Intel Technical Advisory

TA-1167-02

Intel® Server M50CYP Family have a hardware setting that prevents functionality of Intel® Trusted Execution Technology (Intel® TXT)

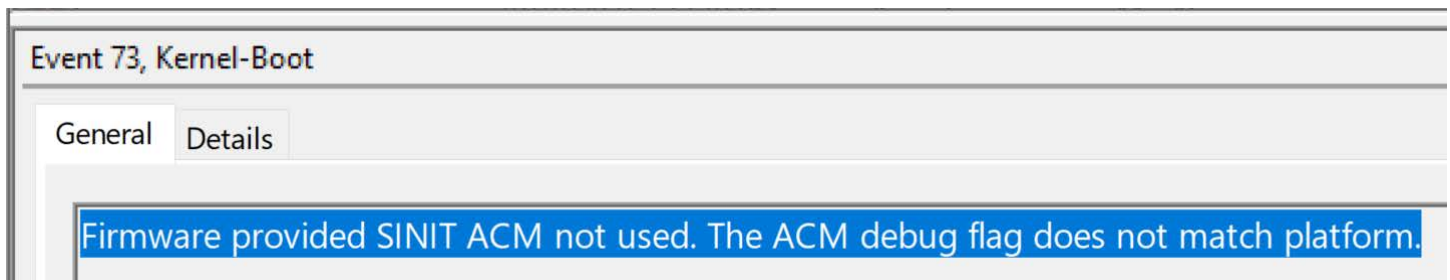
To check in Windows* whether the DIP switch S5_2 is set incorrectly, launch the msinfo32 tool, scroll to the lines beginning with "Virtualization", and check the status of "Virtualization-based security Services Running". If "Virtualization-based security Services Running" does not show "Secure Launch", this means that System Guard Secure Launch is not running and the DIP Switch S5_2 may be set incorrectly, as shown on the following screenshot.

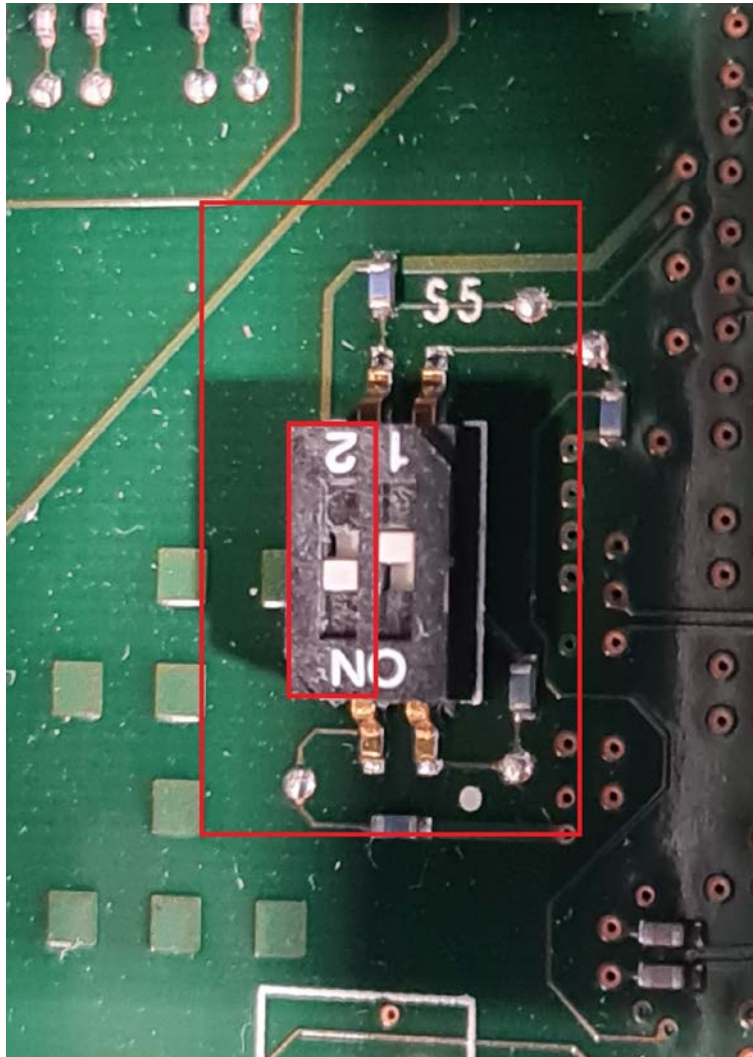
DIP Switch S5_2 switch position on the Intel® Server M50CYP family board is incorrectly set to “ON”, which prevents the system from enabling Intel® Trusted Execution Technology; the S5_2 incorrect switch pin setting can be observed in the following picture.

“Incorrect S5_2 “ON” position”

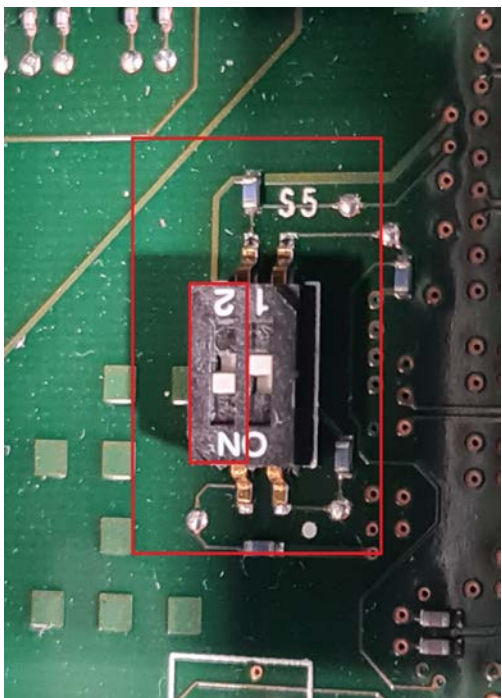
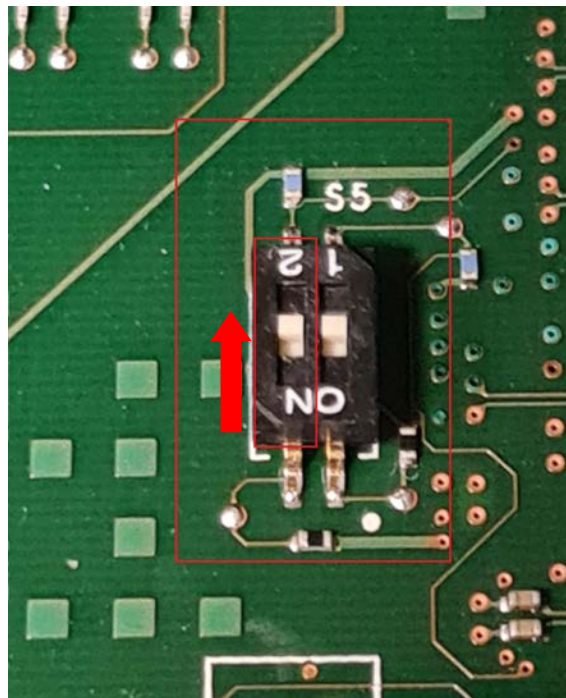
To restore the ability to enable Intel® TXT, the Intel® M50CYP motherboard S5_2 switch pin must be manually moved from “ON” to “OFF” position, as shown in the pictures below. Unplug AC cord from server system before moving the pin number 2 on the S5 switch.

“Correct S5_2 “OFF” position”

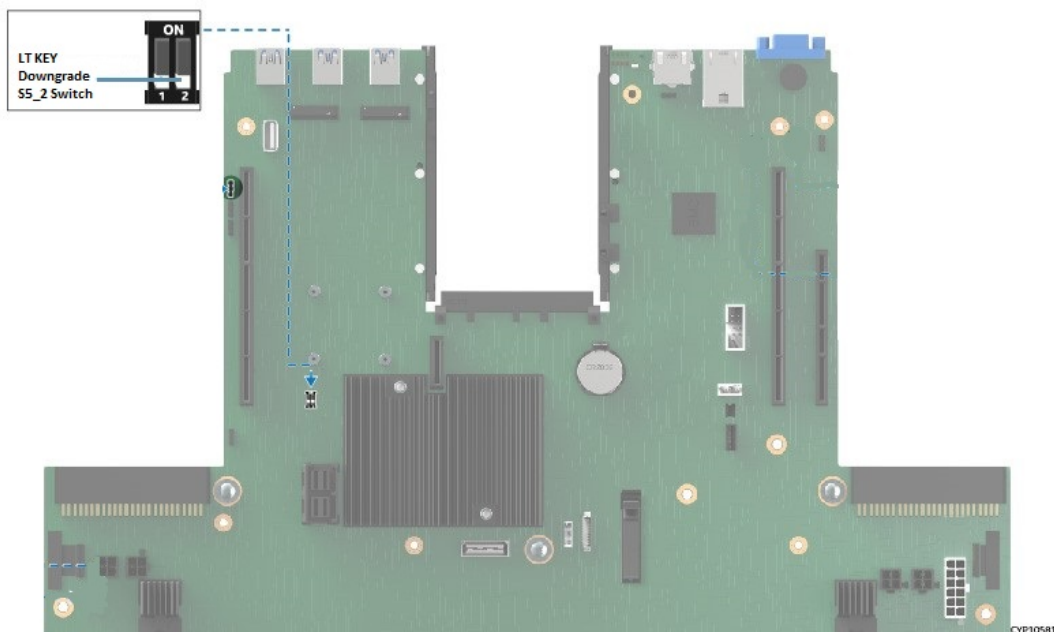
The location of S5 switch can be observed in the picture below:
